From: Gerard Tuckerman <Gerard.Tuckerman@MidCoast.nsw.gov.au>
Sent: Wednesday, 15 August 2018 6:44 PM
To: 'bob@tatland.com.au'; Bruce Moore
Cc: Ledum Yorgure
Subject: RE: Riverside - Channels

Thanks for the time today to discuss and resolve the outstanding issue associated with the existing Myall Quays water quality basin 8c and the southern floodway within the modified Riverside Concept layout. I commend you and Adrian on the professional approach taken by providing analysis based on checking and running the flood models to determine velocities, water levels and storm events which would drive flows within the south branch floodway. The evidence based approach provides confidence to Council that the existing water quality treatment provided by basin 8C for several lots in Leeward Circuit can be suitably modified to ensure that there is no net change in treatment of the existing stormwater discharge as part of the final design of the south branch floodway. The commitment to undertake replacement action of the basin function within Stage 1 and the design work in the first overall DA for the development is satisfactory.

RE: HYDROLOGICAL COMMENTS IN RESPONSE TO COUNCIL'S LETTER OF 19

RIVERSIDE LAYOUT COMPARISON
2013 (RED) vs 2018 (BLACK)

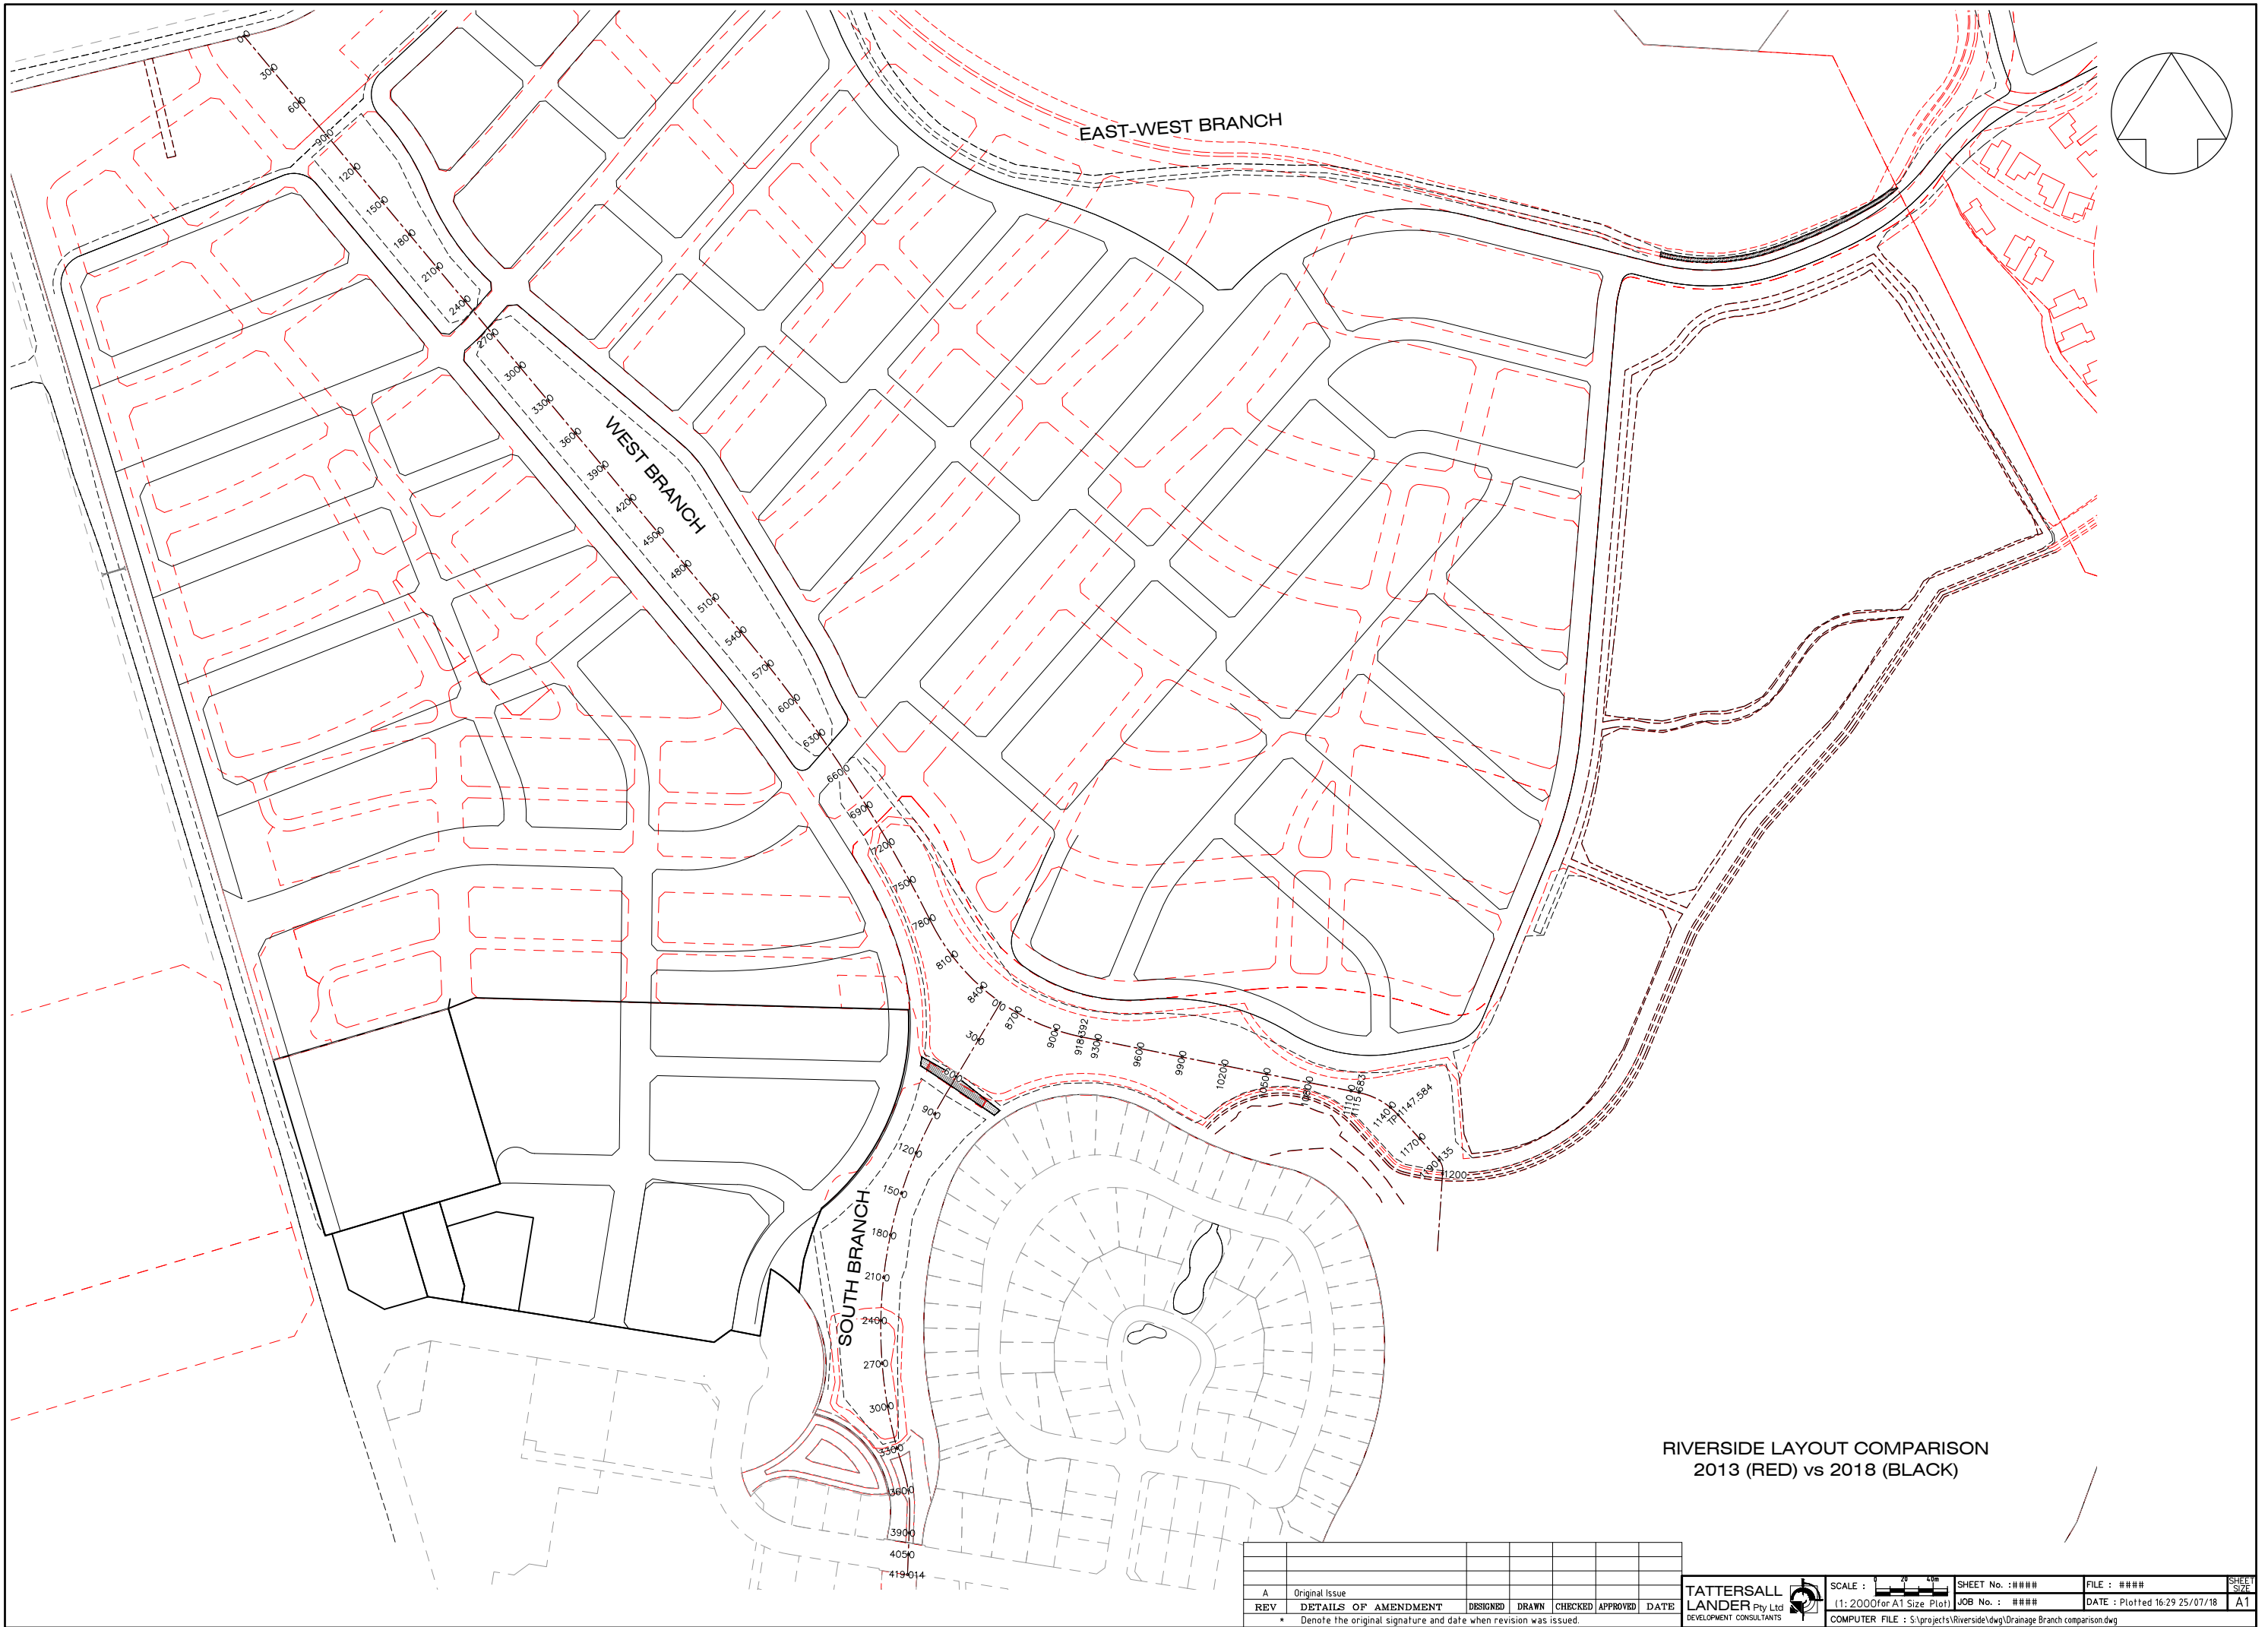
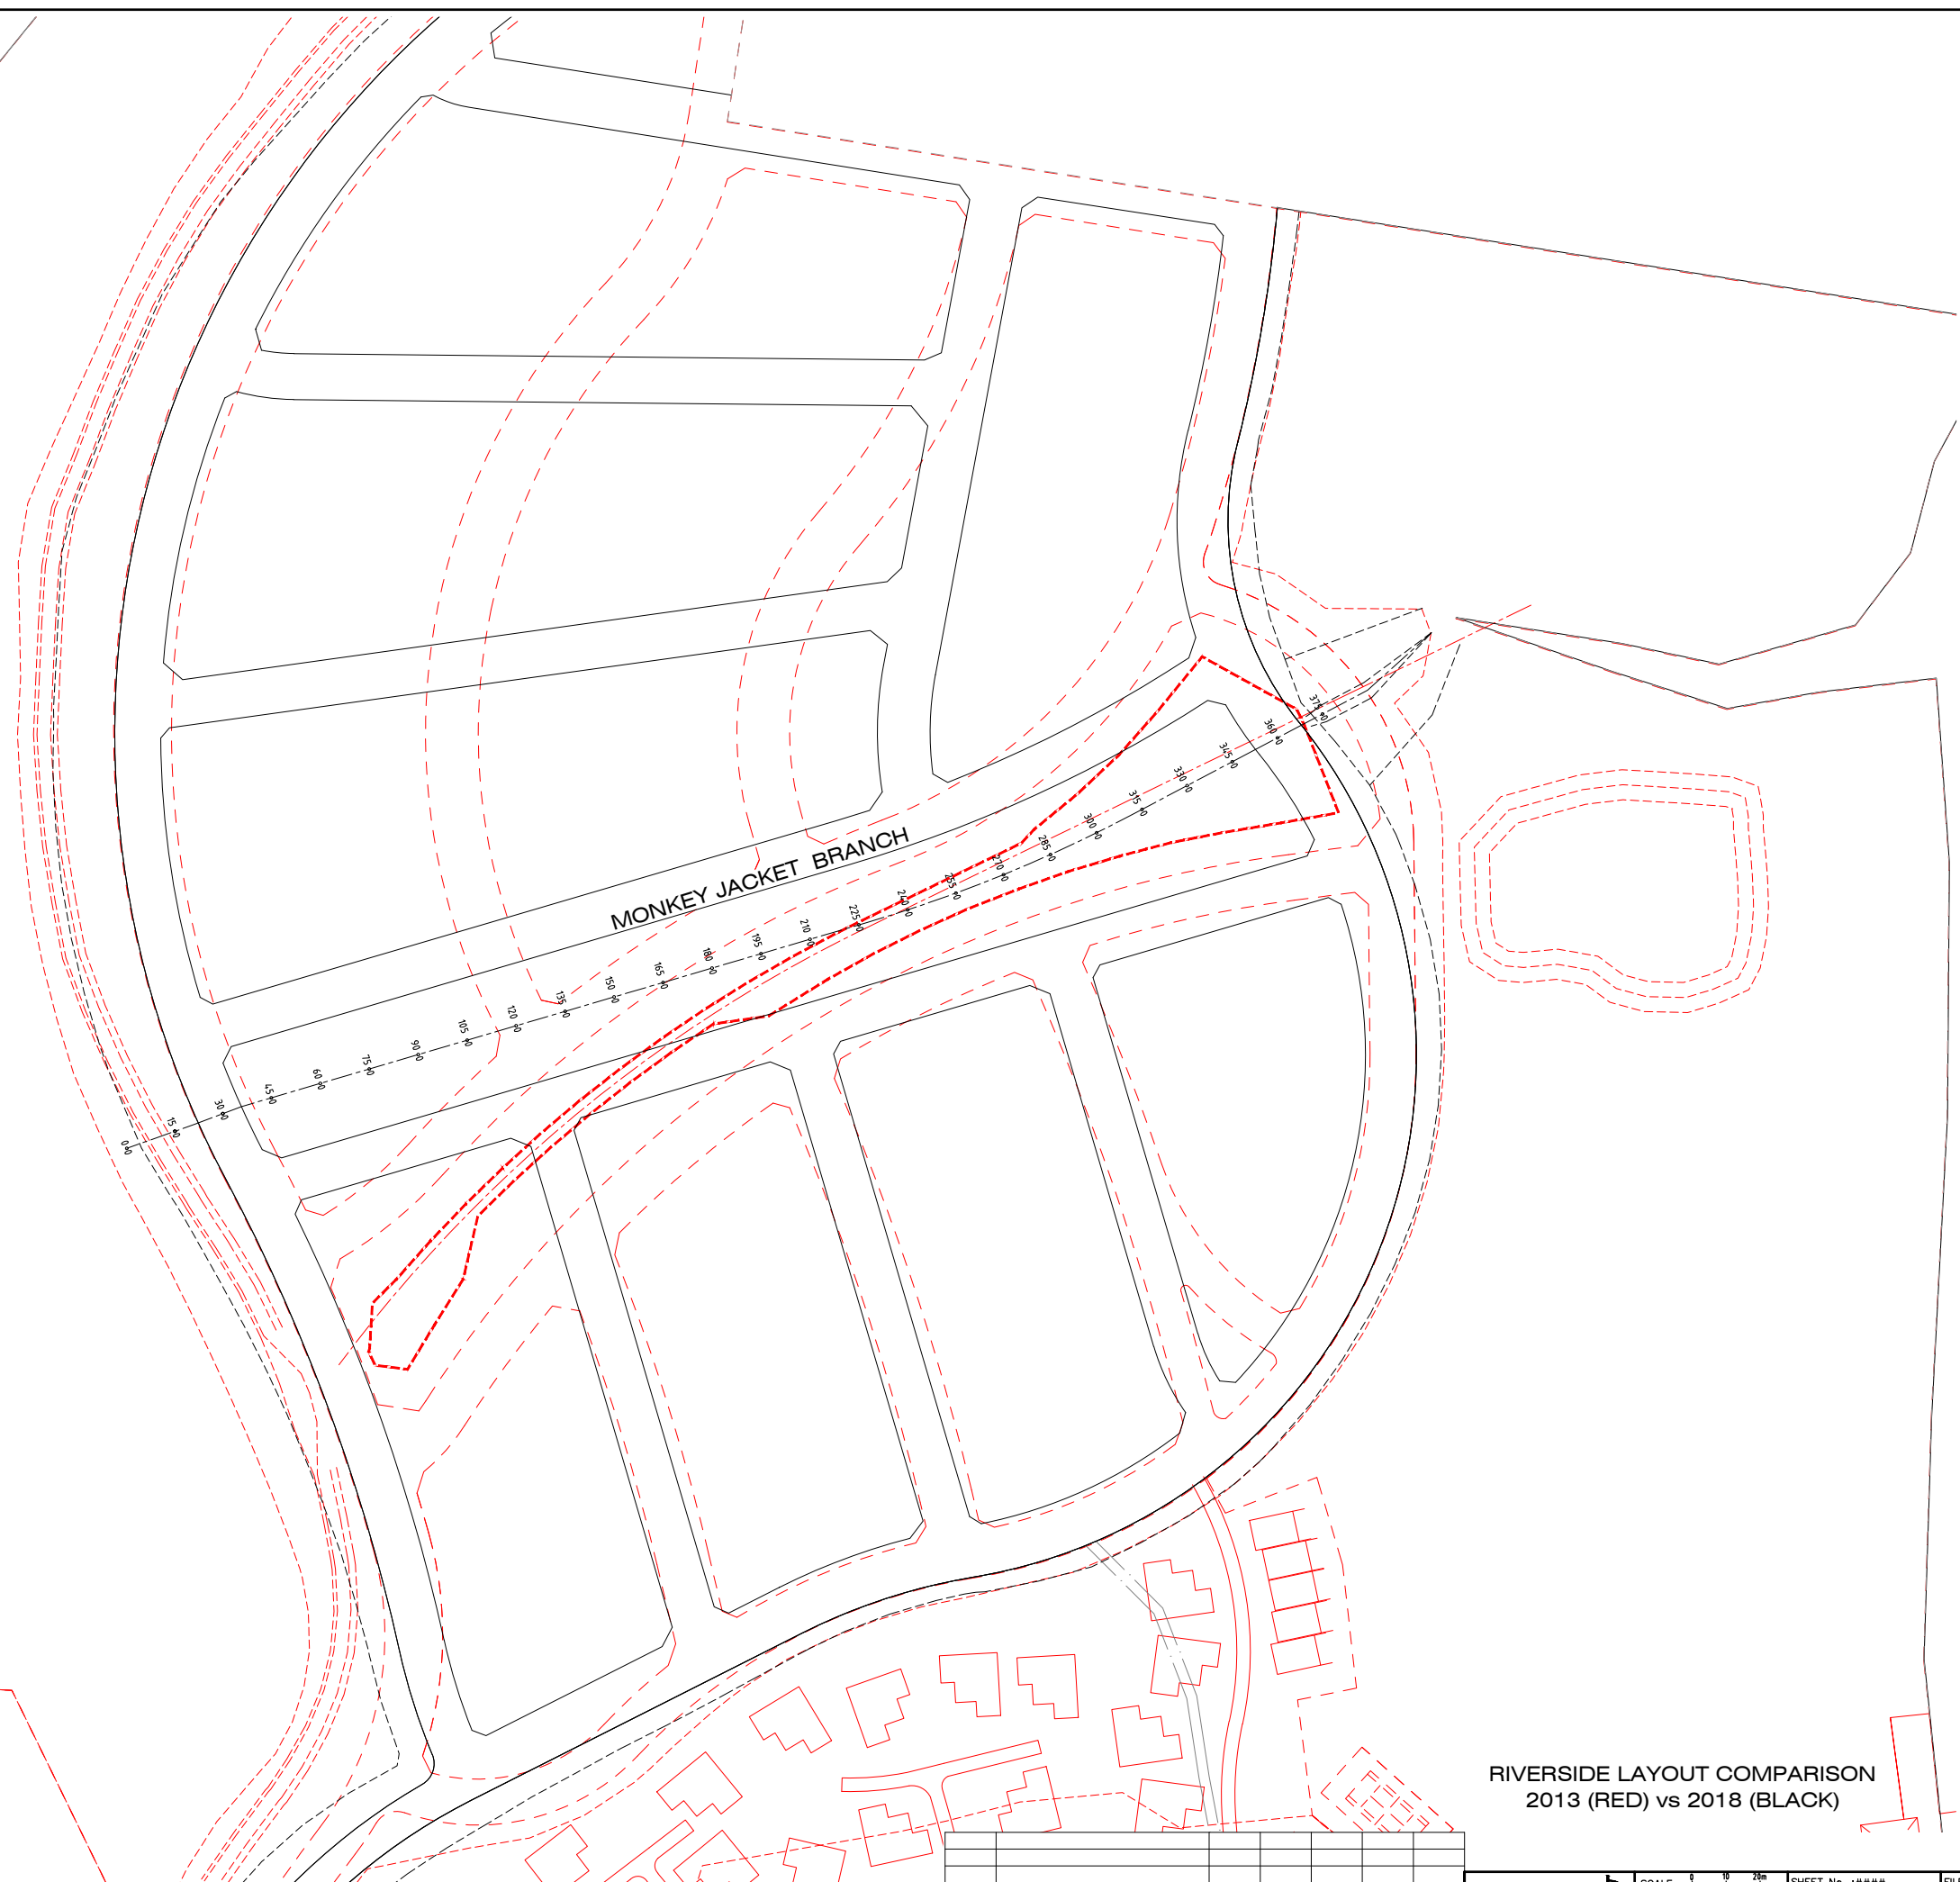
Thanks again for your time on Tuesday. As discussed after the meeting I've looked further into the issue of the drainage channels, their depths and them intercepting the ground water. The most significant changes are in terms of horizontal alignment although you were correct in that one of the channels did get slightly deeper (about 250mm), attached is a comparison plan and sections of the channels and summary from Tattersall Lander of the changes below:

- Monkey Jacket Branch - levels are exactly the same, although the horizontal geometry has changed – the downstream outlet is in the same position, but the upstream end has been shifted approx. 80m north.

- South Branch – Levels and location remain unchanged, other than the removal of the existing basin at the bottom of this corridor – was included in the 2013 modelling as existing but not part of approval.

- West Branch – location unchanged (although upstream end truncated by 90m). Levels unchanged at bottom of site, progressively deepened up to 250mm lower at top end of site. I believe the only place any of these levels appear in the application documentation is where culvert invert levels are noted on the "Preliminary Drainage Design Details" plan as Attachment 1A to the Martens Concept IWCMS report – The document accompanying the modification shows the West Branch upper culvert as U/S Inv 2.0, D/S Inv 1.95m where the document accompanying the approval shows U/S 2.25m, D/S 2.2m. This is the area shown in Figure 18 (reproduced in Daniels email below) as greens so the lowering would just bring it back down to groundwater level. Also note the red area in Figure 18 at the top of this branch is the area now truncated by the modification.
